Directlink

Transmission Determination

Attachment 5

Capital expenditure

Figure 5.1 Directlink's historical vs forecast capex (\$2019–20, million)

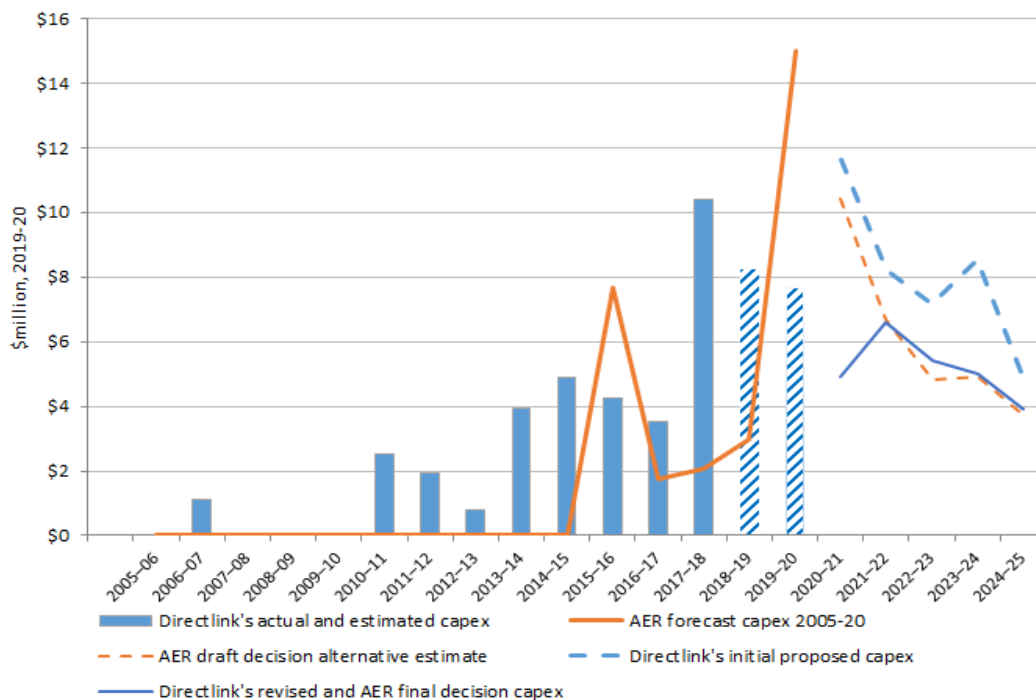
One of the capex factors that we are required to have regard is the electricity network provider's actual and expected capex in previous regulatory control periods.²⁴ Directlink's capex proposal in this context appears reasonable when compared with longer-term average historical levels of capex (see Figure 5.1). However, we also consider that Directlink's historical levels of capex may not be a good guide to future investment requirements due to the variable nature of expenditure for a single asset (as opposed to larger TNSPs with more evenly spread recurrent capex relating to a broader portfolio of assets).
